# GVT Bus Storage & Maintenance Facility

**FCI Constructors, Inc.**  
Request for Information 003  
Detailed, RFIs Grouped by RFI Number with Cost

<b>CNG Maintenance Building</b> 333 West Avenue, Grand Junction, CO	<b>Project #</b> 10-12-016 Tel: tbd Fax: tbd	<b>FCI Constructors, Inc. - GJ</b>
<b>RFI #:</b> 003	<b>Answered By:</b> Justin Mendenhall	<b>Date Created:</b> 8/13/2012
<b>Author Company:</b> FCI Constructors, Inc. - GJ P. O. Box 1767 Grand Junction, CO 81502	<b>Author Company:</b> FCI Constructors, Inc. - GJ P. O. Box 1767 Grand Junction, CO 81502	<b>Author By:</b> Justin Mendenhall
<b>Co-Respondent:</b>	<b>Author RFI Number:</b>	
<b>Subject:</b> Phone & IT Conduit Locations	<b>Discipline:</b> Architectural/Electrical	<b>Category:</b> Clarification
<b>Company Name:</b> Magnum Electric Co, Inc.	<b>Contact Name:</b> Jeff Anderson	<b>Telephone Number:</b> 970-243-9855
		<b>Fax Number:</b> 970-243-1458
<b>Cost Impact:</b> No	<b>Drawing Impact:</b> Yes	<b>Schedule Impact:</b> No
<b>Question:</b>		<b>Date Required:</b> 8/20/2012
<b>Reference Drawing(s):</b> A1.0

**FLEET SERVICES**  
MAINTENANCE BUILDING & RETRO-FIT  
RFP-3410-12-DH

**POWER PLAN**  
SCALE: 1/4"=1'-0"  
NORTH

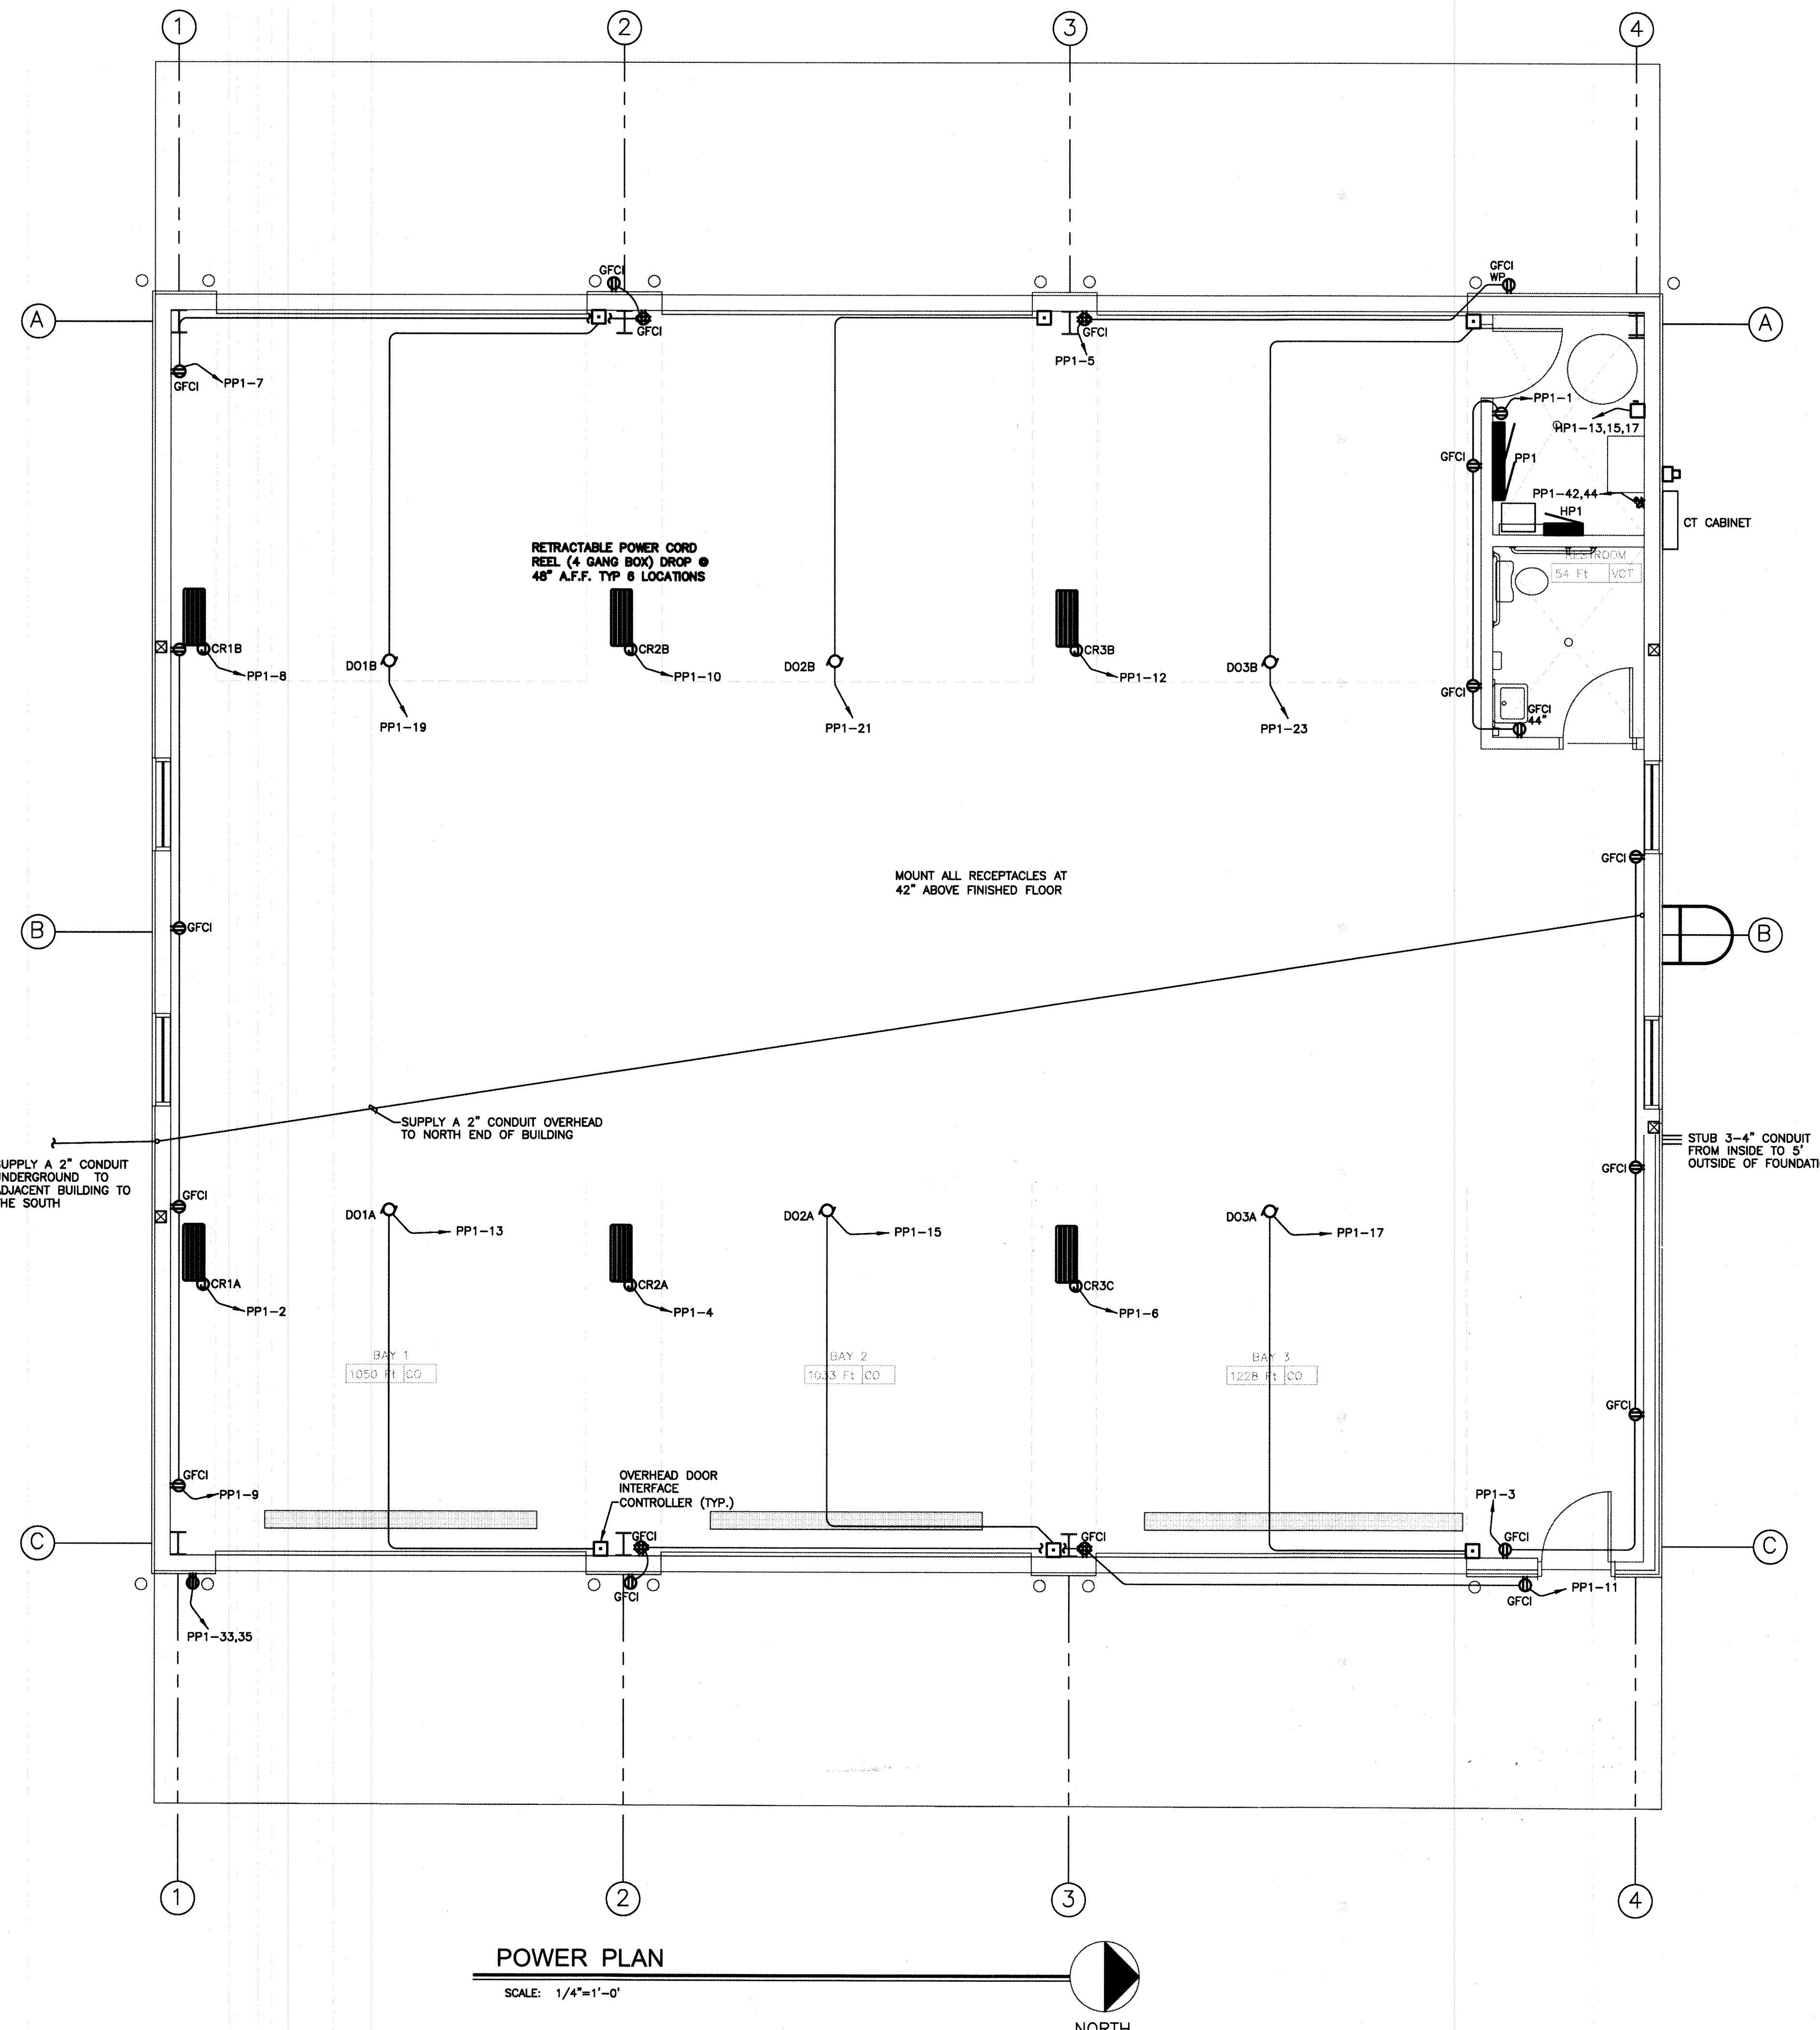
Subject	Discipline	Category
EM Light Fixture Location	Architectural/Electrical	Clarification

Answer This is for documentation only, no response is required. Date Answered: 7/24/2012
